Subject: Duke Energy Corporation
Catawba Nuclear Station, Unit 2
Docket Number 50-414
Response to Request for Additional Information
for Unit 2 Reactor Coolant System Cold Leg Elbow
Tap Flow Coefficients

Responses to NRC Questions Concerning Catawba Unit 2 RCS Flow and Flow Instrumentation

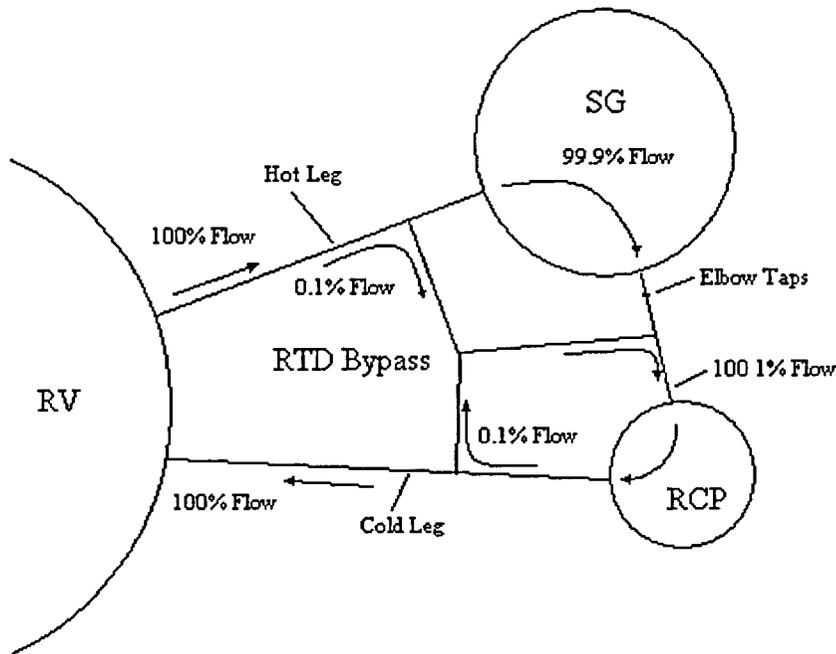
Provide a numerical example of the modeling of the RTD bypass manifold in the analytical flow model.

The analytical flow model is designed to produce a total RCS flow prediction based on the total system pressure drop. With the RTD bypass manifold in place several components of the system pressure drop needed to be revised to account for the flows redirected to the bypass manifold. The drawing below displays the relevant areas of one of the RCS loops and the associated flows:

As can be seen from the above drawing the diversion of 111 gpm ($\approx 0.11\%$ flow) to the RTD bypass from the hot leg will result in a decreased flow of 99.9% flow through the steam generator and elbow tap portion of the crossover leg. Therefore, the elbow tap measured loop flow will be low by the amount of the diverted portion of flow. In addition to the hot leg diversion of flow, a small amount of flow, 172 gpm ($\approx 0.18\%$ flow), is also diverted from the cold leg to the RTD bypass manifold. The combined diverted hot and cold leg flows are then directed back to the RCS loop in the crossover leg downstream from the elbow taps. This results in an increase in loop flow (100.18% flow) through the reactor coolant pump to the cold leg diversion point. The loop flow once again returns to 100% flow in the cold leg as the flow returns to the reactor vessel.

In order to model the RTD bypass manifold in the analytical flow model the flow used to adjust the pressure drops through the components affected are increased or decreased as appropriate to produce the correct pressure drops. In this case, the flows through half the hot leg, the steam generator, and half the crossover leg are decreased by 111 gpm to reflect the diverted RTD bypass flow from the hot leg. This results in the 100% flow in the hot leg being reduced to approximately 99.9% flow through the steam generators. Likewise, the flows through the reactor coolant pump suction, weir plate and half the cold leg are increased by the returned RTD bypass flows of 111 and 172 gpm. This results in the 99.9% flow from the crossover leg to the pump suction being increased to approximately 100.18% flow through the reactor coolant pump to the cold leg. Once the flow passes the cold leg diversion to the RTD bypass manifold then the flow is decreased by 172 gpm to reduce the flow back to 100% flow. For example, when the changes described above are made to the analytical model for the August 1986 data. The following ΔP changes result:

Figure 1
Analytic Model vs. Elbow Tap Flow Comparison, RCS Total Flow

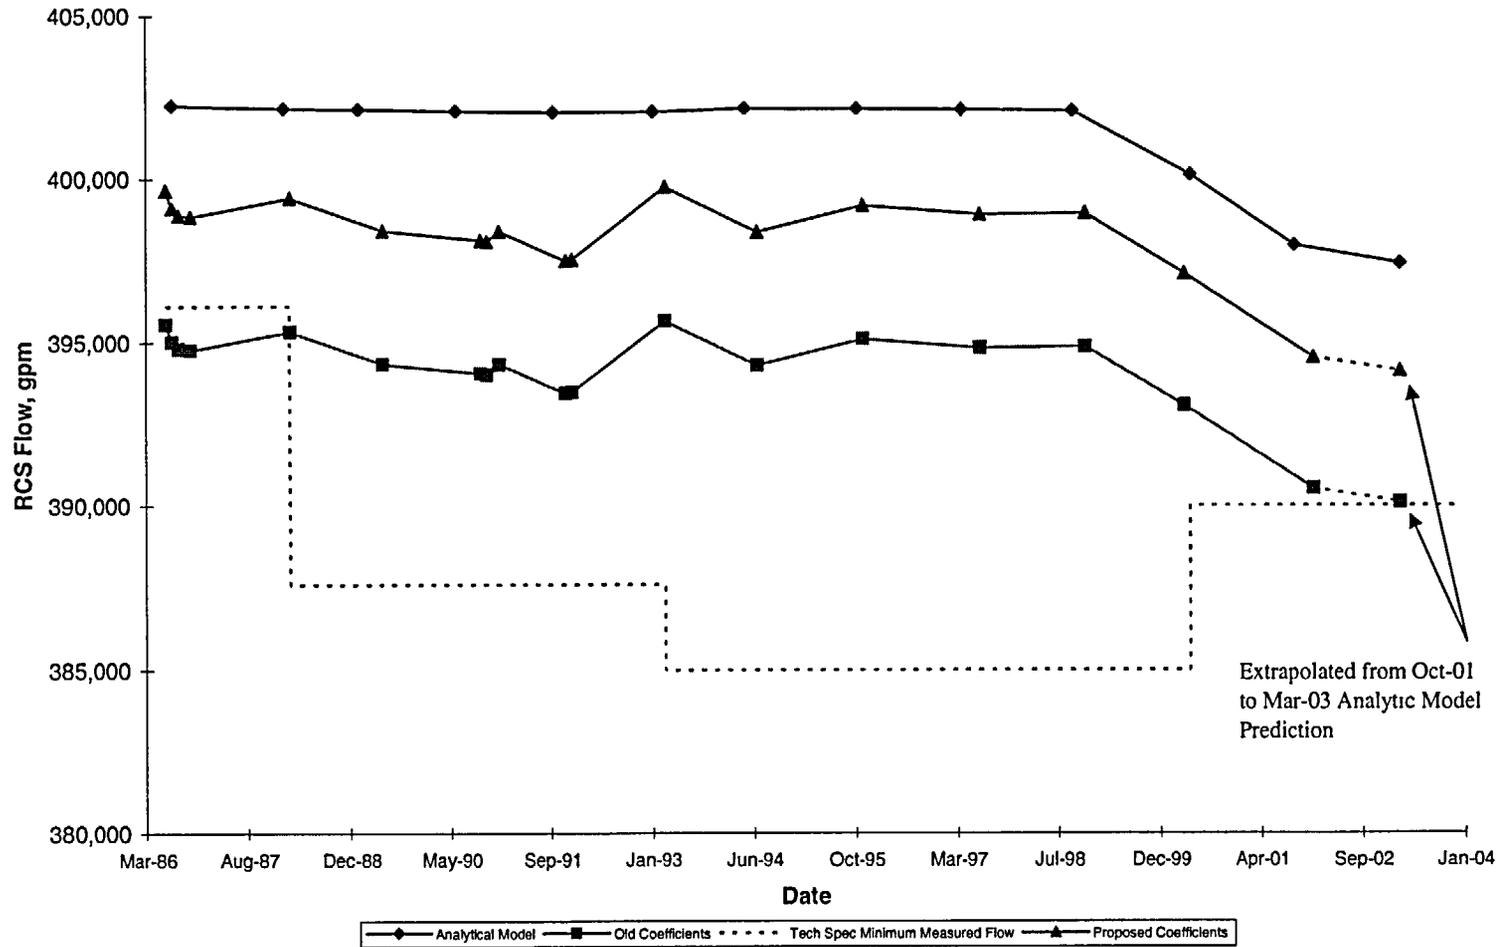
The Catawba Unit 2 total flowrate (Refer to Figure 1 of the 2/7/2003 submittal) as indicated by the elbow tap instrumentation indicates a decrease in flow in the October 1991 and the February 1993 data, followed by an increase in flow. Explain this data trend relative to the flow prediction of the analytical model, which shows no significant flow change.

Updated graphs of total flow and loop flows using the recalculated ΔP readings are attached as Figures 1 through 5.

Based on the above research, Duke believes that the decrease in the RCS flow shown in the 1993 data is directly attributable to the discrepancy between the transmitter scaling and the OAC scaling. The methodology used to empirically determine the static pressure effects may have been an additional contributor for the flow decrease but cannot be verified. The anomalous results for two of the twelve transmitters cannot be explained conclusively. None of the other potential causes listed above was found to explain or contribute significantly to the unexpected flow decrease seen in 1991 and April 1993.

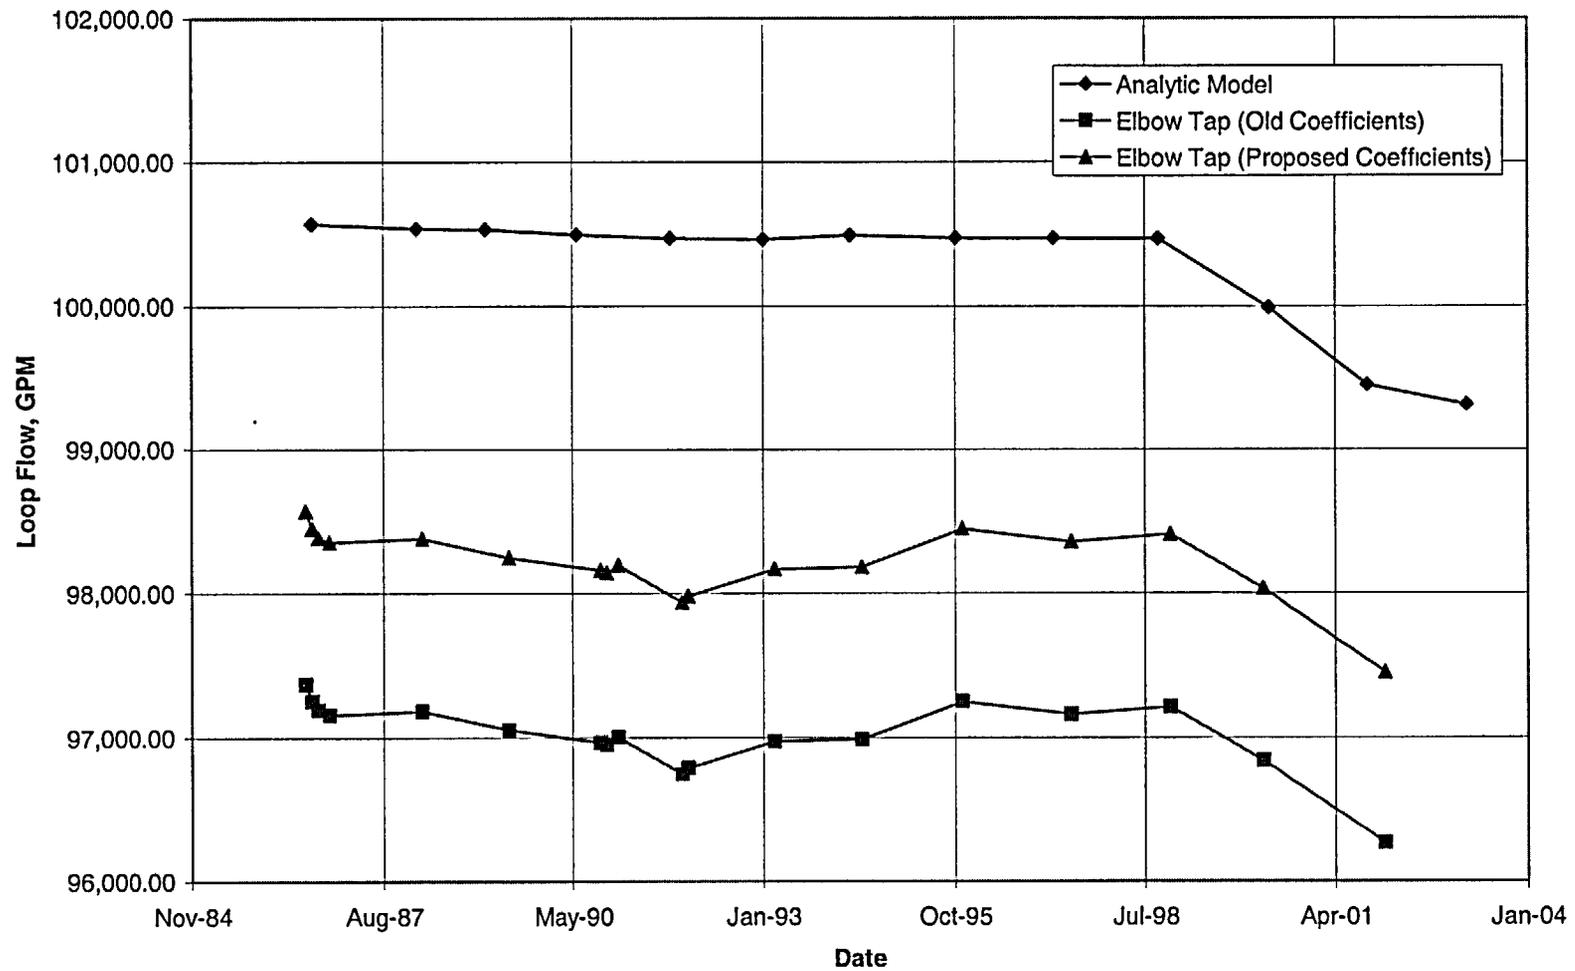
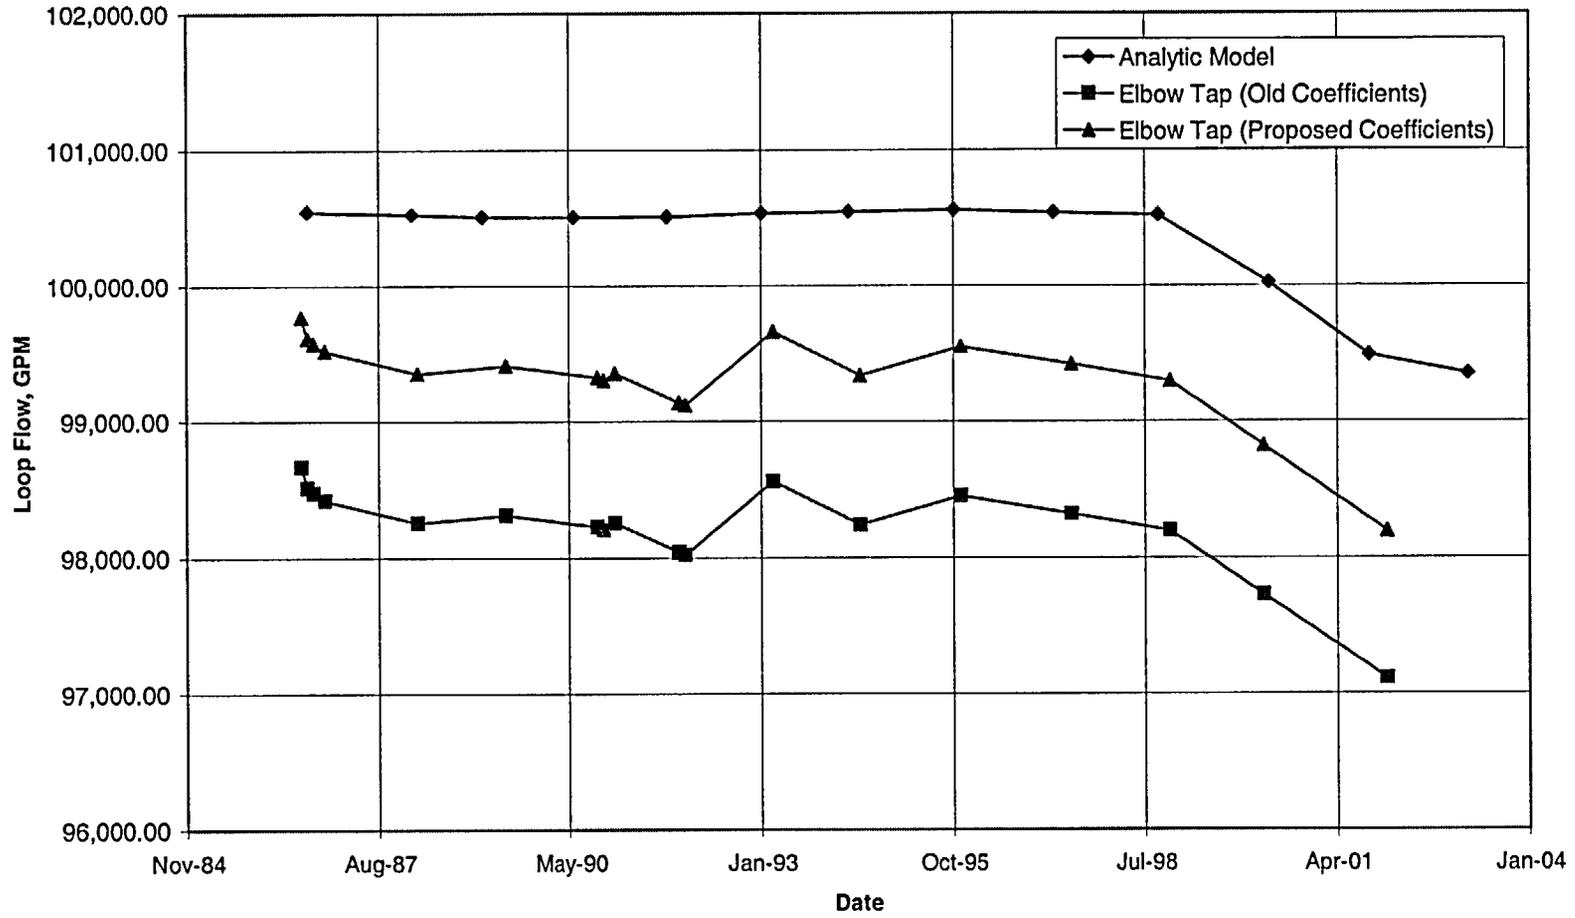
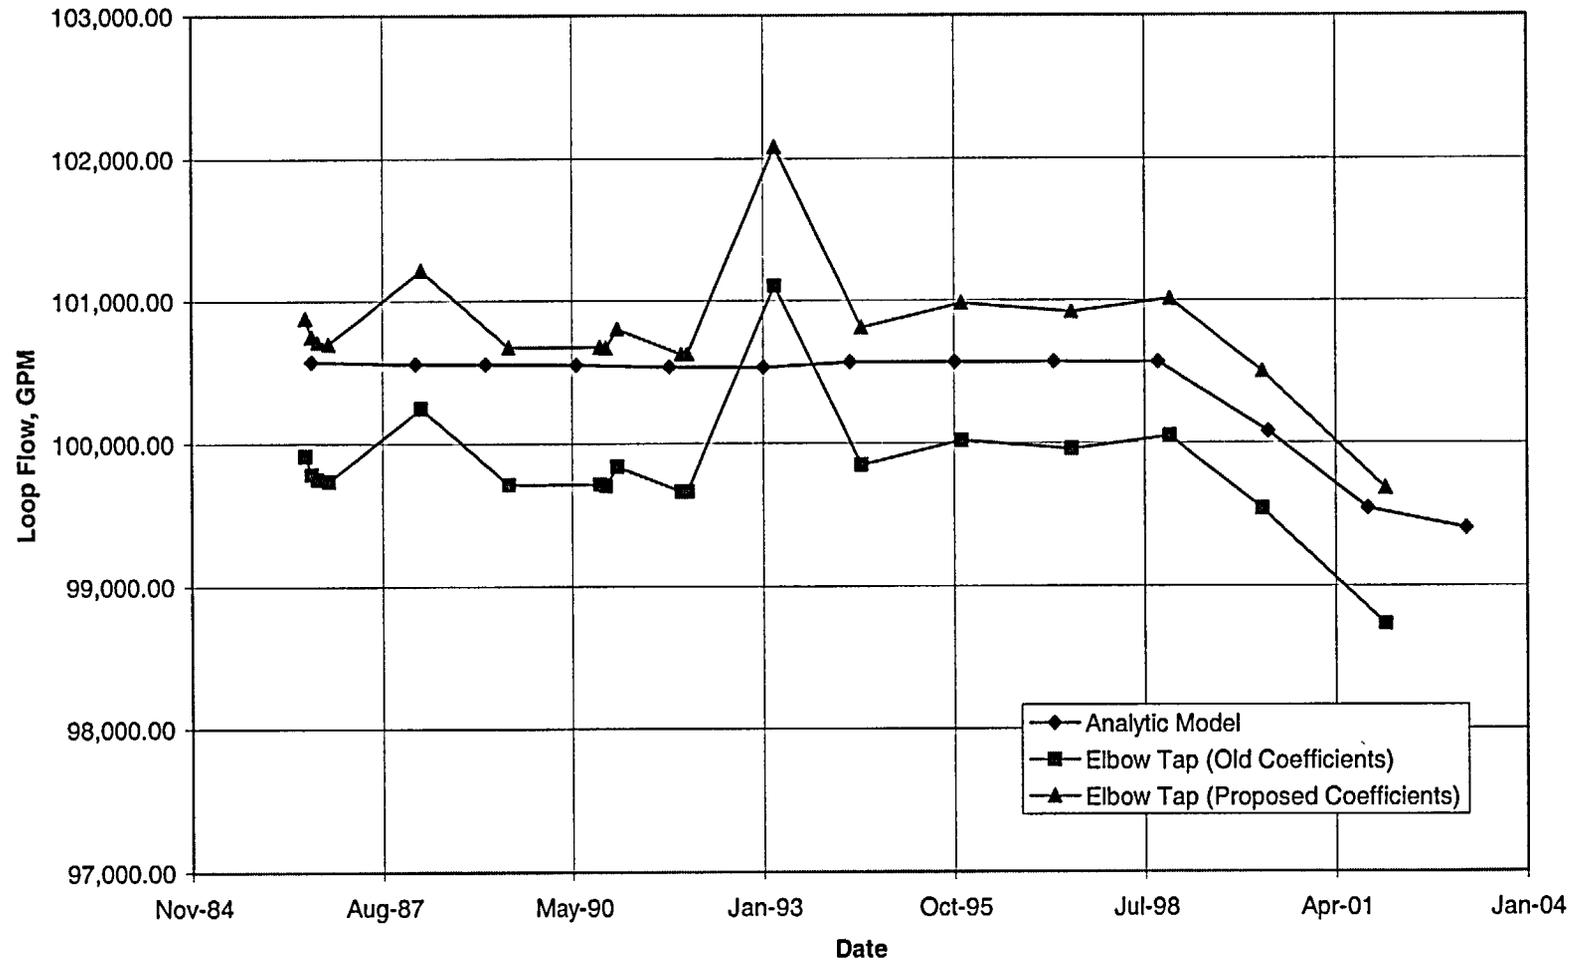
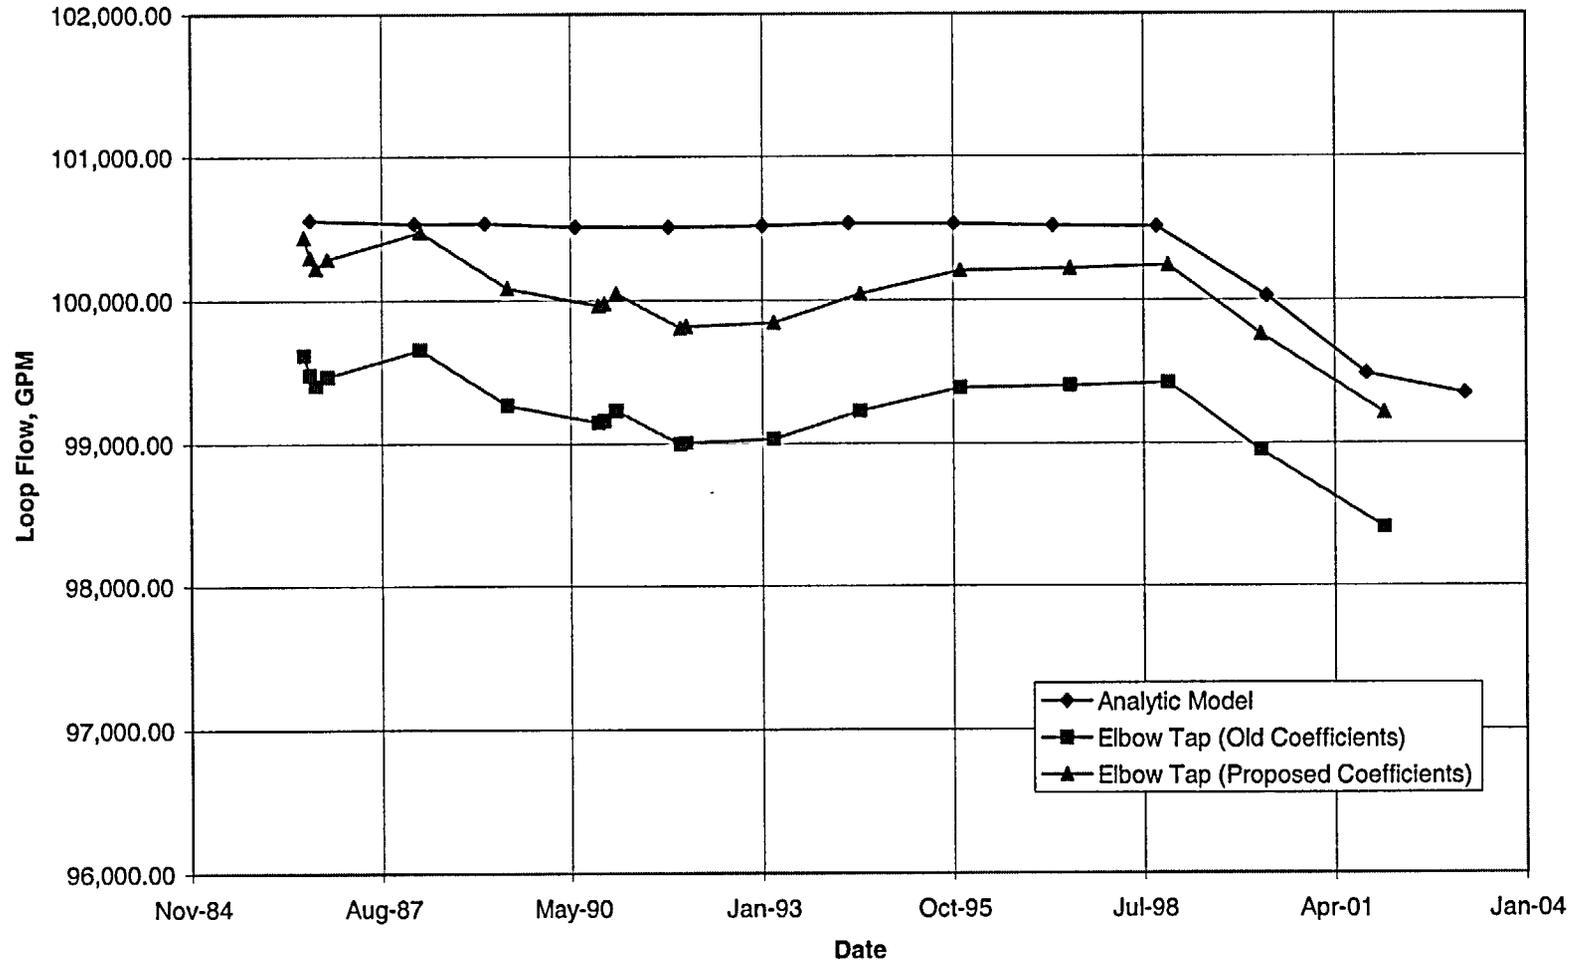
Confirm that the fuel assembly ΔP values used in the analytical model have been normalized to the correct flowrate.

The analytical model assumed that the reactor vessel internal flow distribution was not affected by a change in fuel assembly ΔP . Determine the change in loop flow when this effect is taken into account.

Fuel assembly flow testing is performed by the fuel vendors to determine the form loss coefficient values and the pressure drop along the fuel assembly. These tests are usually performed at conditions significantly different from the expected plant full power conditions. Following testing the results are analytically scaled to provide the ΔP values at conditions corresponding to full power operating conditions. Duke obtains these data from the vendors and they are used in the analytical model. The Westinghouse OFA fuel assembly ΔP is 21.6 psi at a reference flow of 406,800 gpm, and these values are used in the analytical model. The Mk-BW fuel assembly ΔP is 2.4% lower than the OFA fuel assembly at a reference flow of 403,600 gpm, but was incorrectly modeled at a reference flow of 406,800 gpm in the analytical model. Using form loss coefficients provided by Westinghouse, the Westinghouse RFA fuel assembly ΔP is 25.1 psi at a reference flow of 390,000 gpm, but was incorrectly modeled at a reference flow of 406,800 gpm. These changes in addition to the changes described in the response to Question 4 result in a decrease in the predicted March 2003 analytical model flow of 829 gpm or 0.2%. Figures 1-5 have been updated to reflect these changes in the analytical model.

The analytical flow model has assumed a constant reactor vessel internal flow distribution based on calculations performed by FANP for Mk-BW fuel at the time that the analytical model was developed. The value used for Catawba Unit 2 is a total core bypass flowrate of 5.7%. This data was not changed in the analytical model for Westinghouse fuel. Duke has now evaluated the change in the RCS loop flow using 7.02% core bypass flow based on Westinghouse calculations for Westinghouse RFA fuel in Catawba Unit 2. To make this comparison consistent, a spreadsheet was developed to approximate the change from the 7.02% value for Westinghouse fuel by substituting the 25.1 psi core pressure drop for RFA fuel at a reference flowrate of 390,000 gpm to 20.75 psi for FANP Mk-BW fuel at a reference flowrate of 403,600 gpm. The core bypass flow then decreases to 6.17% for FANP Mk-BW fuel. A similar change for Westinghouse OFA fuel based on 21.6 psi at a reference flow of 406,800 gpm resulted in a core bypass flow value of 6.24%. These changes in the core bypass flow as the fuel design transitions from OFA to Mk-BW to RFA are then input to the analytical model. These changes in addition to the changes described in the response to Question 3 result in a decrease in the predicted March 2003 analytical model flow of 829 gpm or 0.2%. Figures 1-5 have been updated to reflect these changes in the analytical model.
